**REF120051 (Carmel Lagoon Ecosystem Protective Barrier, Scenic Road Protection
Structure, and Interim Sandbar Management Plan Project)
CEQA Comments regarding Draft EIR**

Review period of December 2, 2016 through January 31, 2017

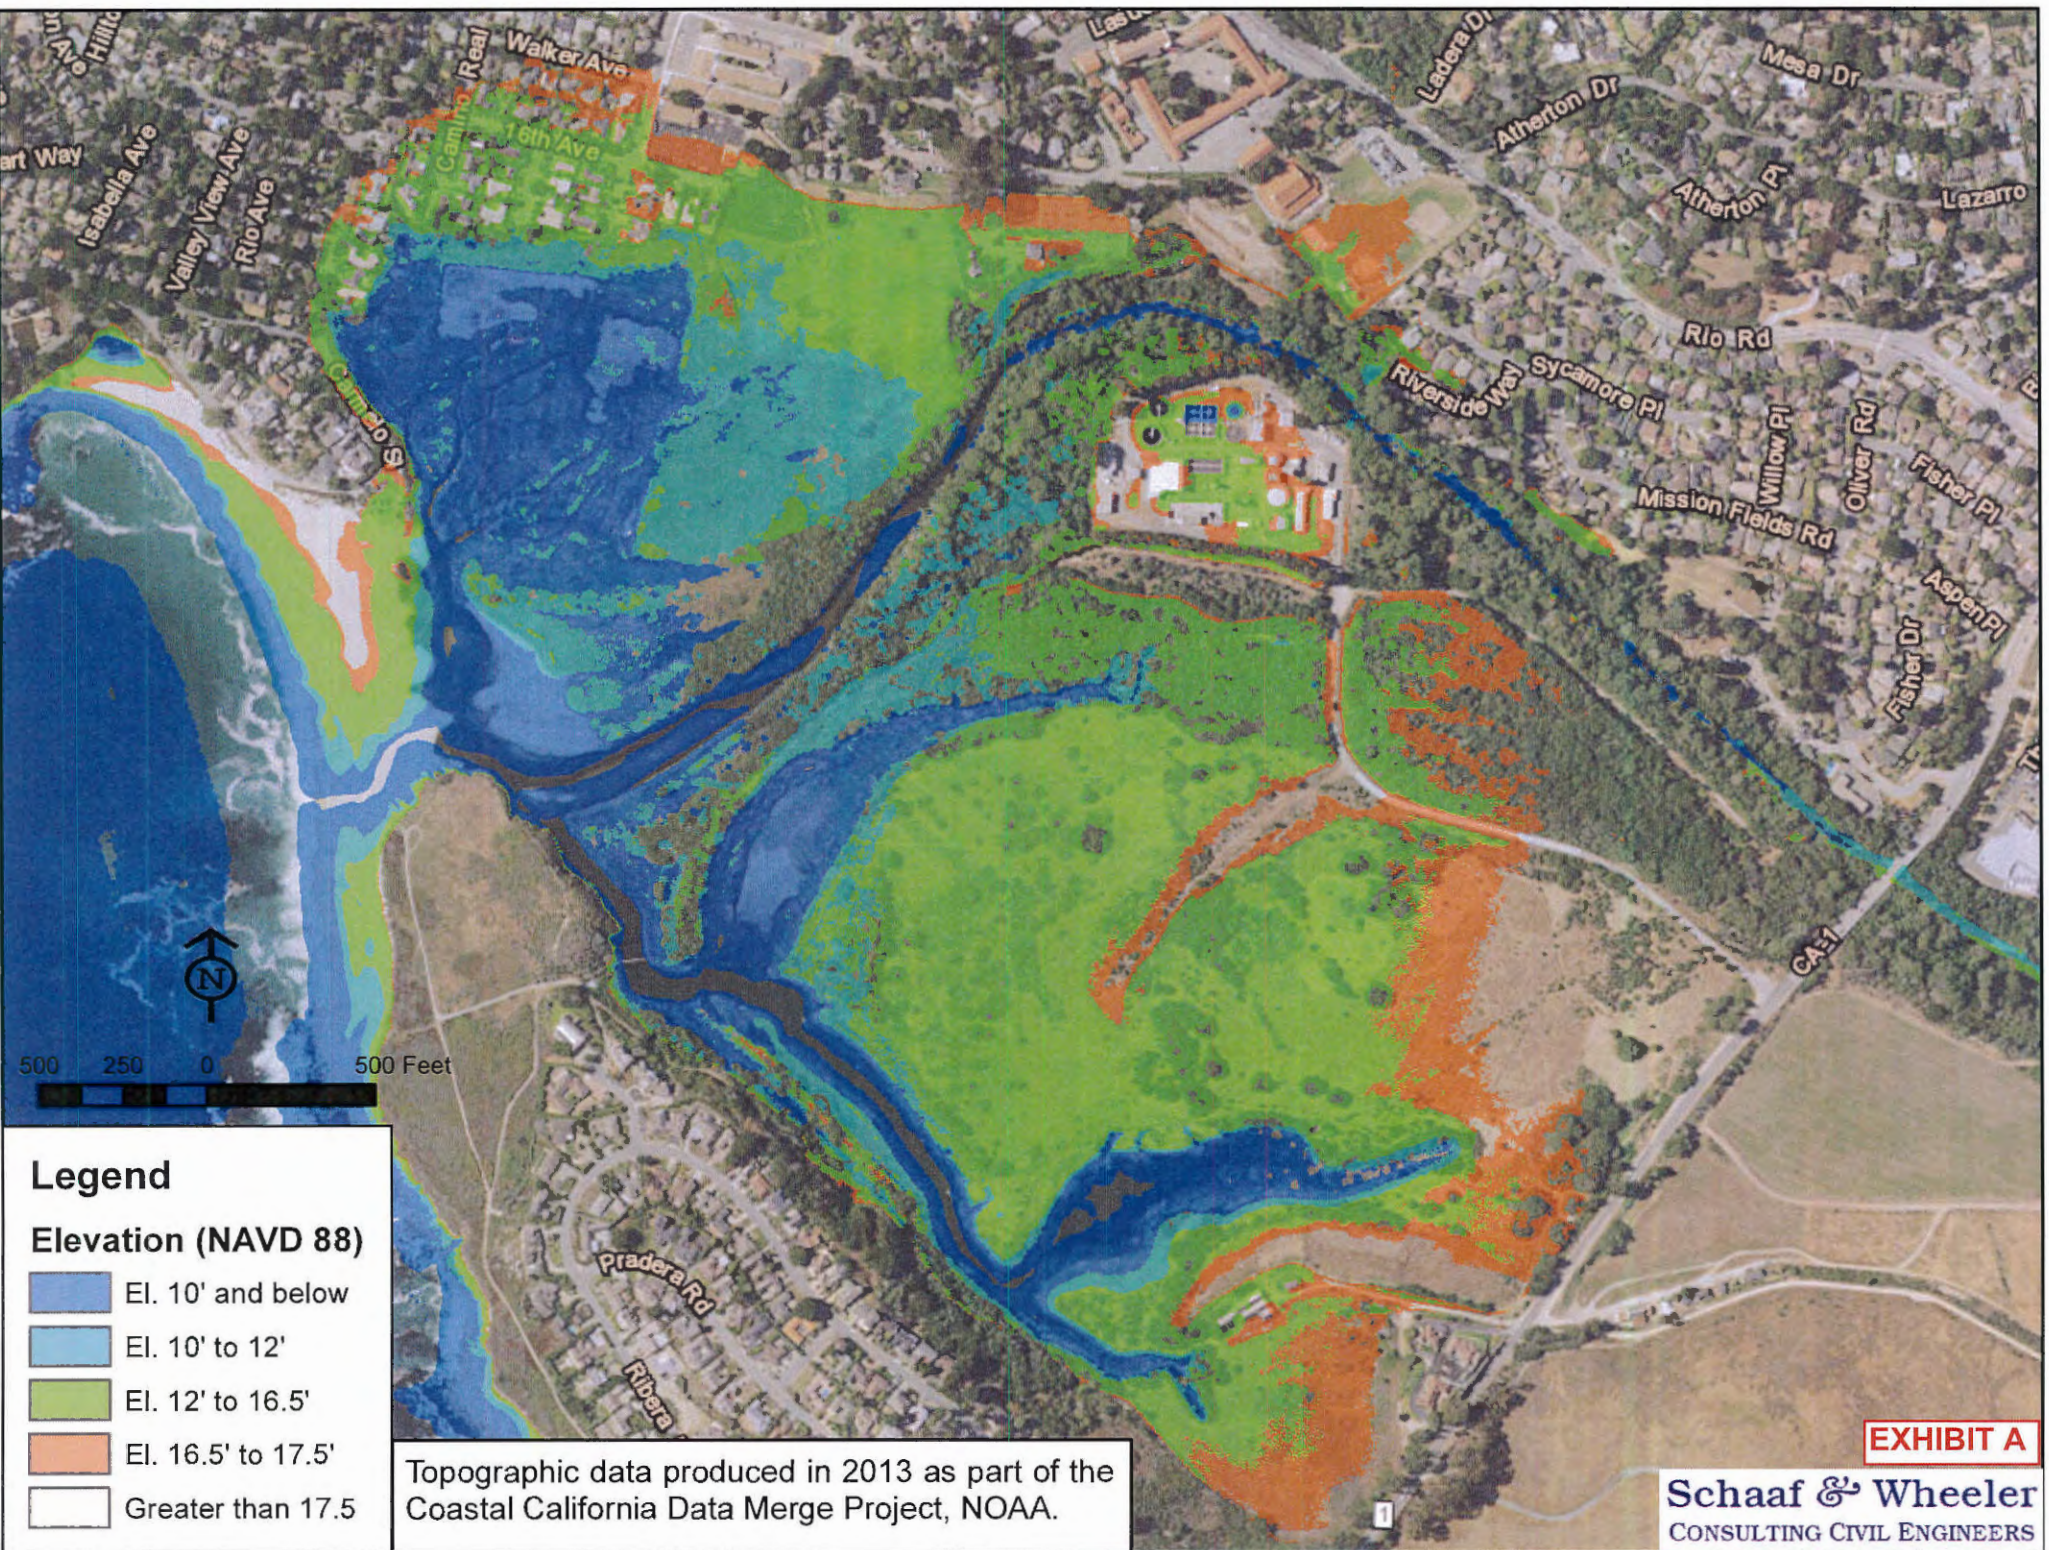
After further review of the lagoon contours, one alternative that was not presented in the DEIR, but that CAWD believes should be analyzed, is the possibility of deepening the south finger of the lagoon or another location along the river where fish habitat could be better maintained. If the fish species of concern could be provided pools further up river from the sand bar there may be less impact to these species allowing for different lagoon management to be a more favorable alternative that might have a lower level of impacts to CAWD property than the proposed project. In the opinion of the District Engineer, there may be additional benefits to this approach in the future as the community begins to better understand sea level rise impacts.

The maps included with this letter were prepared by Schaaf & Wheeler, who are Consulting Civil Engineers with expertise in water resources engineering and analyzing floodplain hazards. The technical comments in this letter, as well as those included in CAWD's earlier letter, were prepared at the direction of the District Principal Engineer, Drew Lander C.P.E. Prior to his employment with CAWD, Mr. Lander was employed by Napa County as a land use development engineer where he also served as a County Flood Plain Manager. During his tenure with Napa County Mr. Lander was licensed through the Association of State Floodplain Managers (ASFPM) as a Certified Floodplain Manager and performed

FIGURE 1
5/15/2005

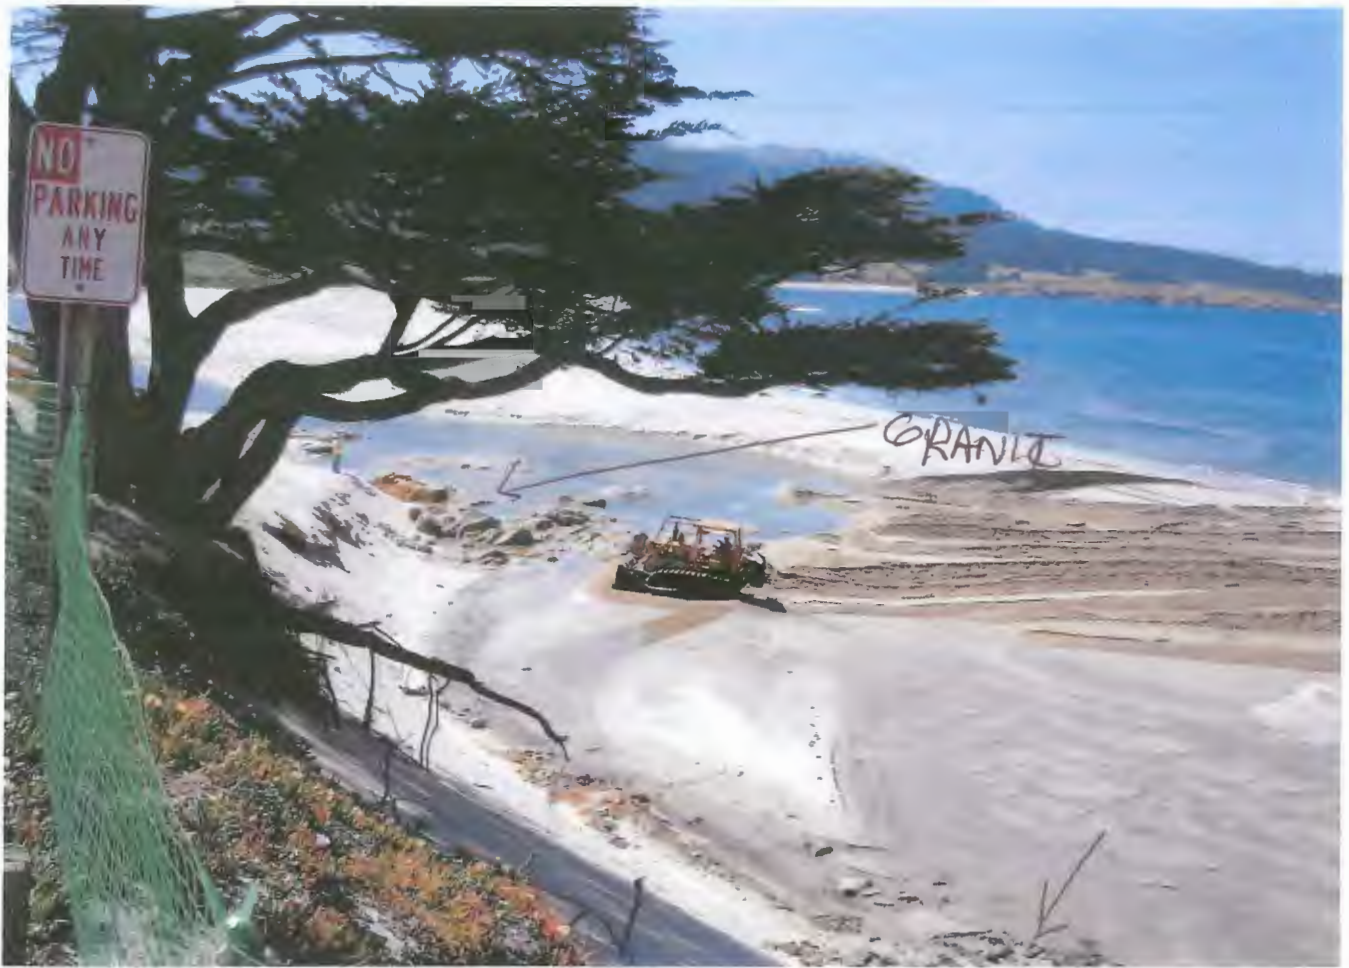
1. Between the parking lot and the heritage Cypress Tree there are granite outcroppings of irregular height, and possibly areas amongst them with no bedrock. (Figure 1 on 5/25/2005)

FIGURE
2

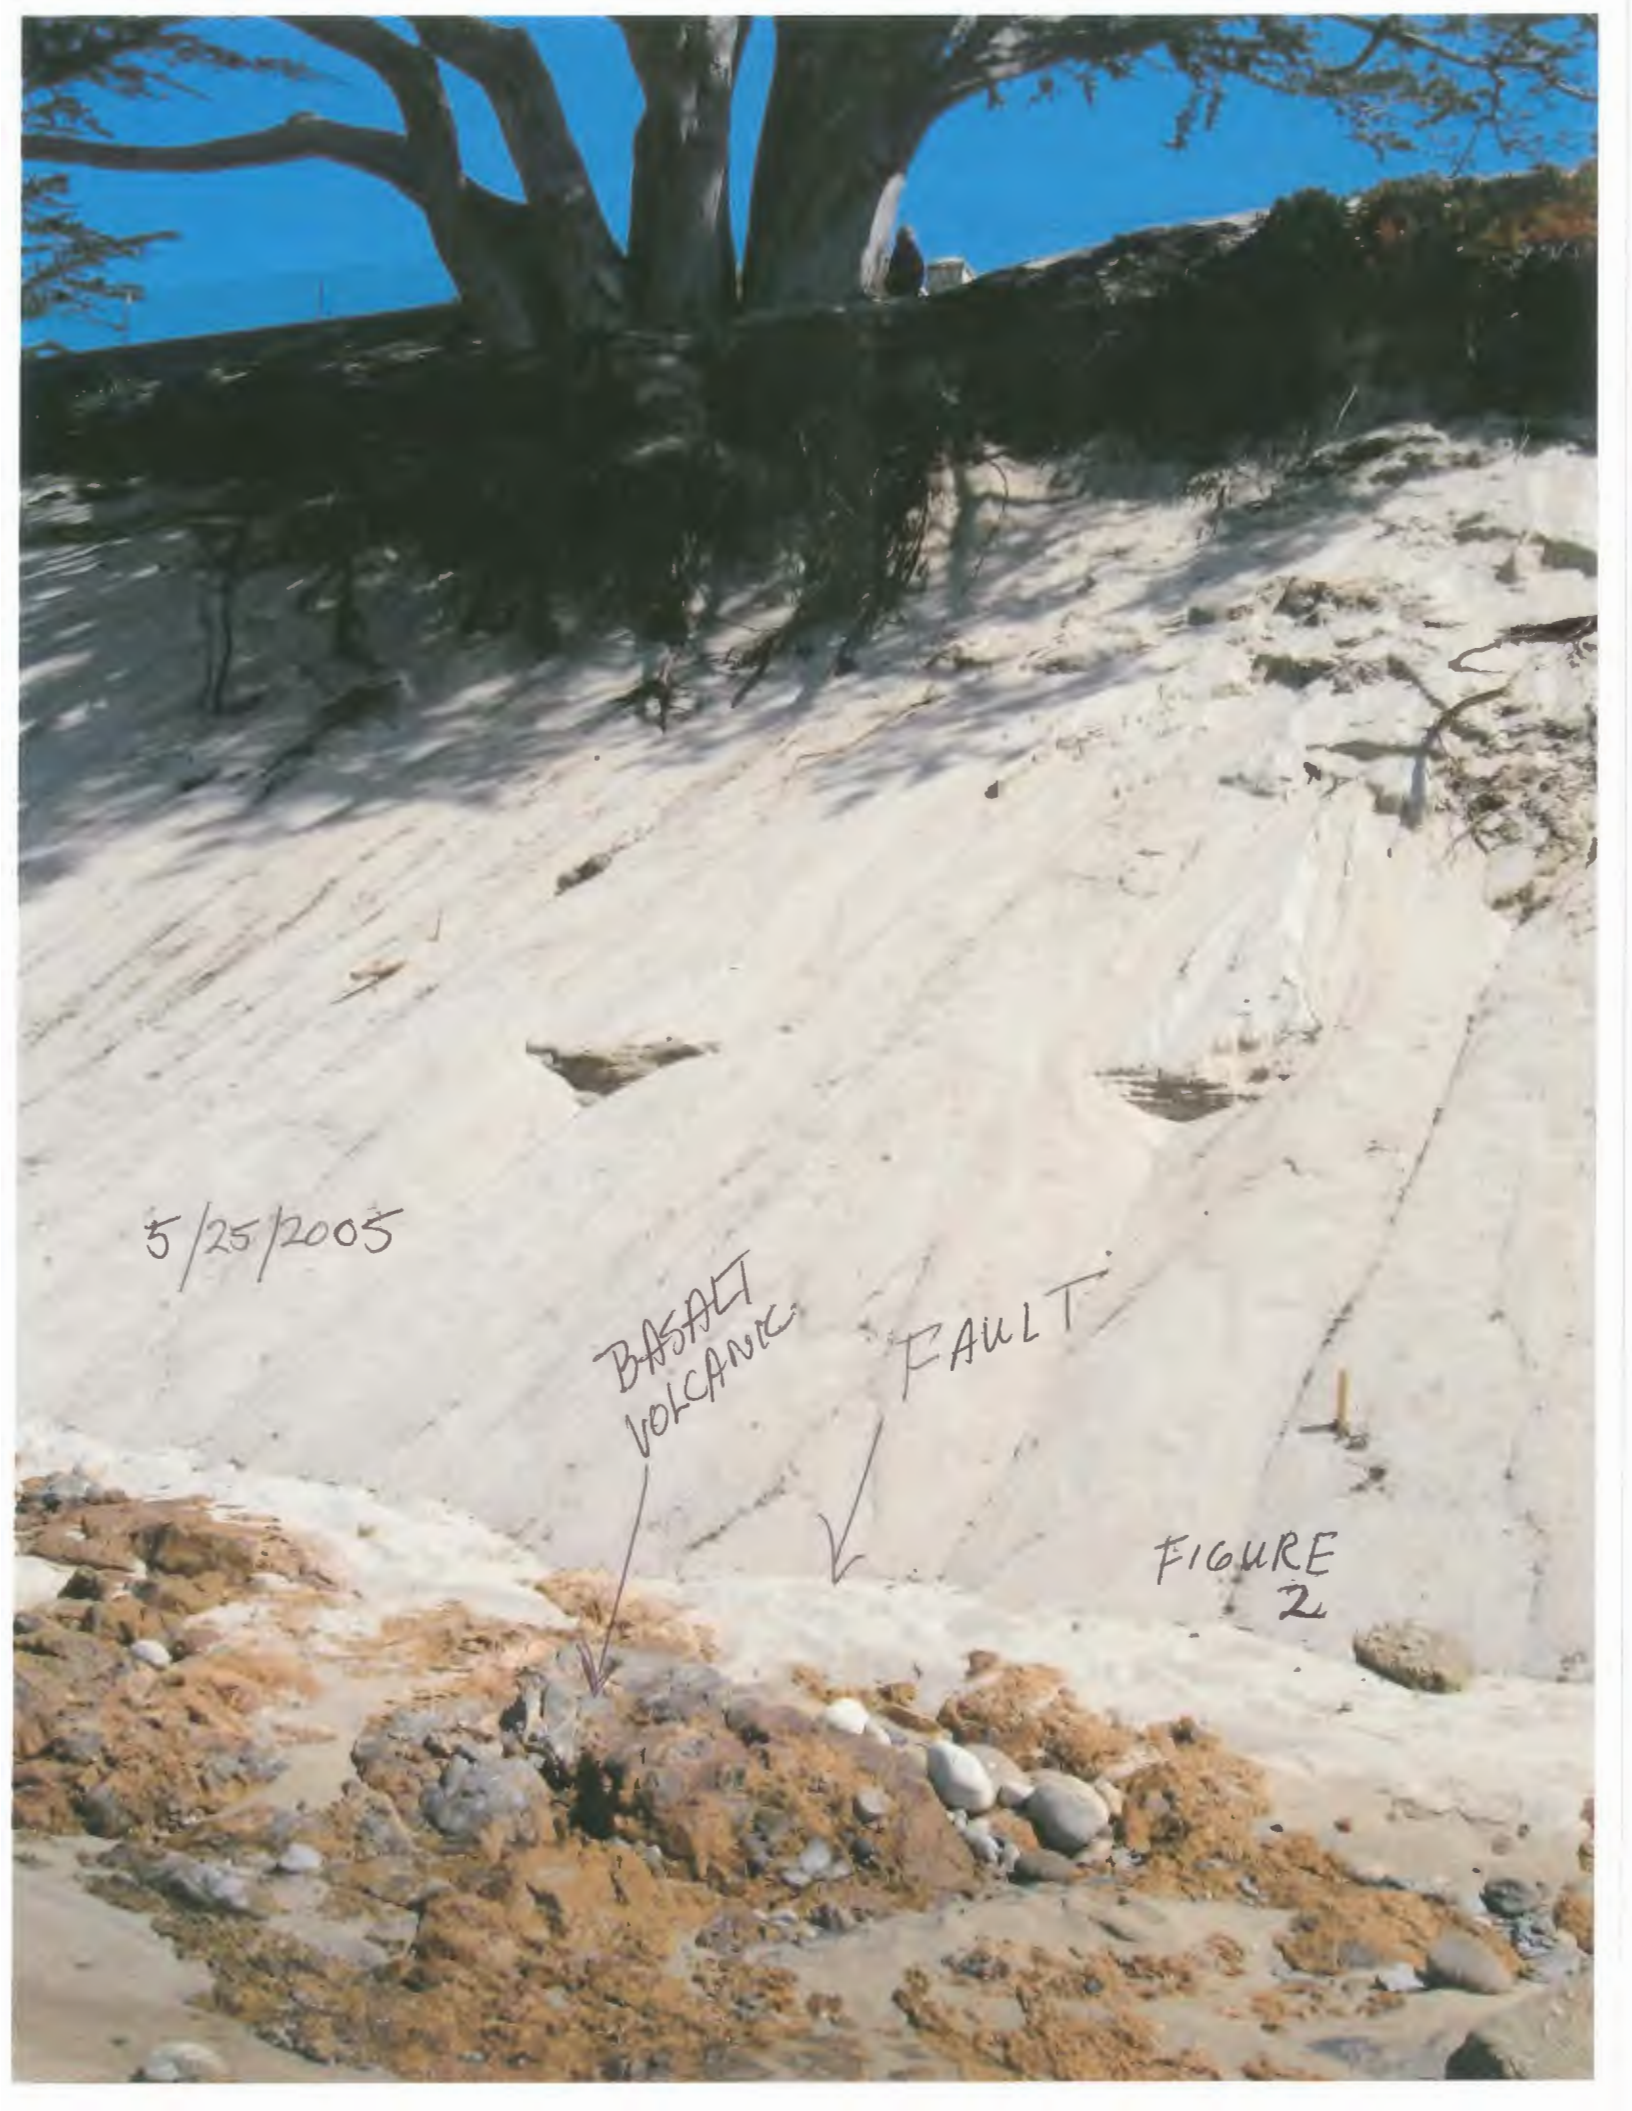
2. Then near the base of the bluff below the heritage Cypress there is a transition to a basaltic black rock mixed with orange rock that may constitute a fault according to Doug Smith CSUMB geology professor. (Figure 2-4 on 5/25/2005)

FIGURE 10

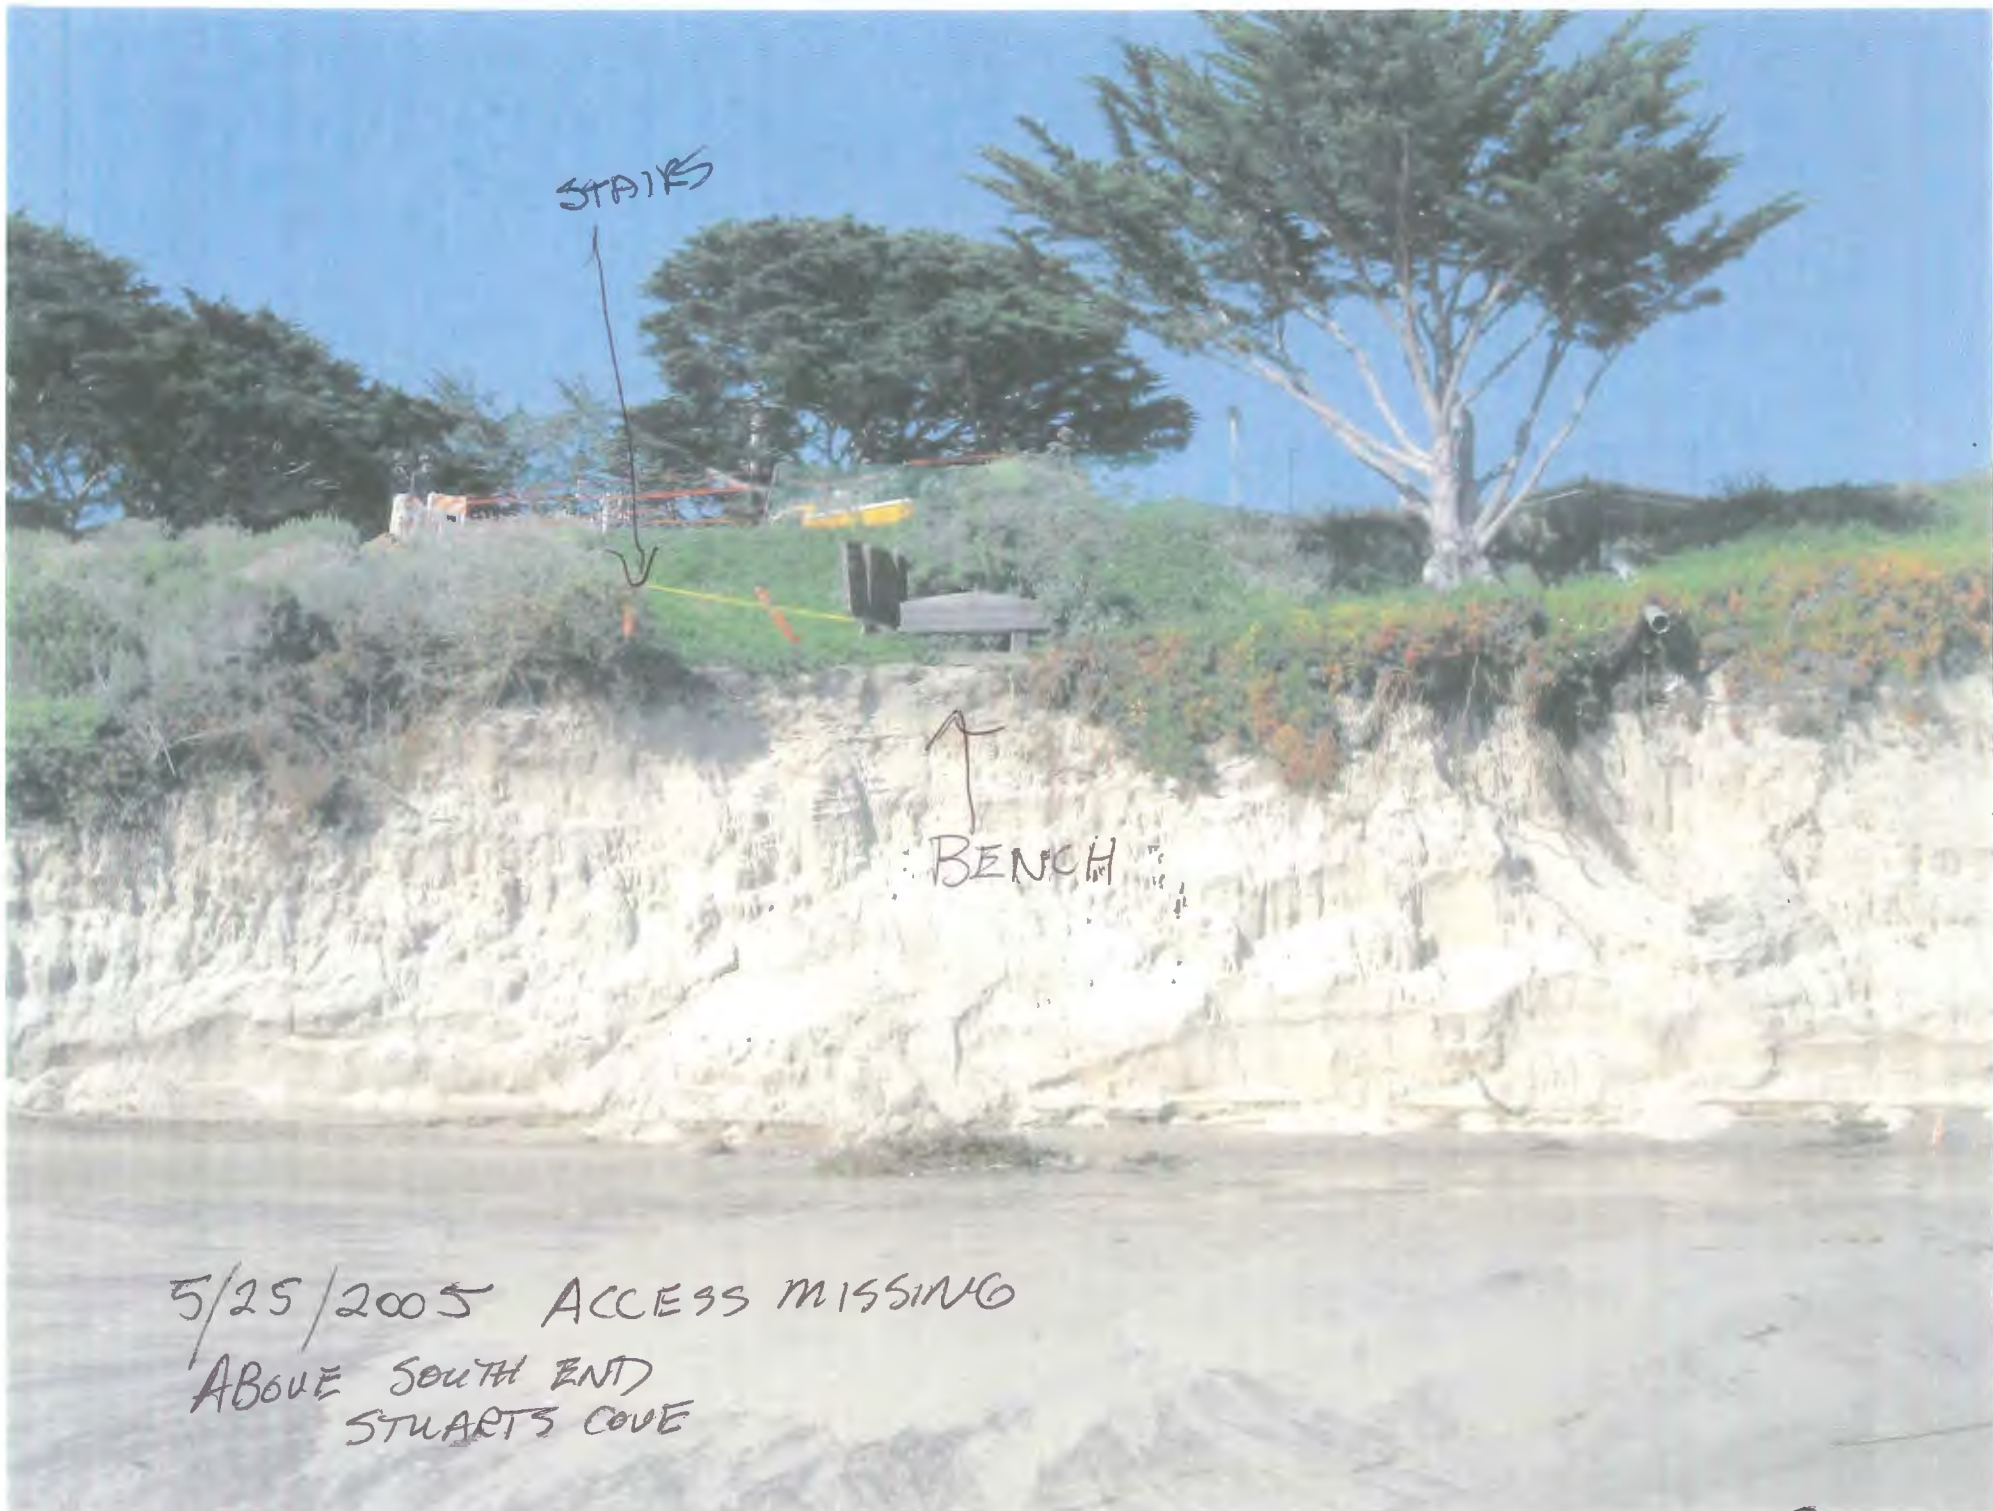
4. In the cove itself the eroded bank what appeared from the road to be basaltic rock was actually moist friable clay that could be picked up by the handfuls. When this was still exposed, all of this was documented by Doug Smith, a professor of Geology at CSUMB. (Figure 10, 5/25/2005)
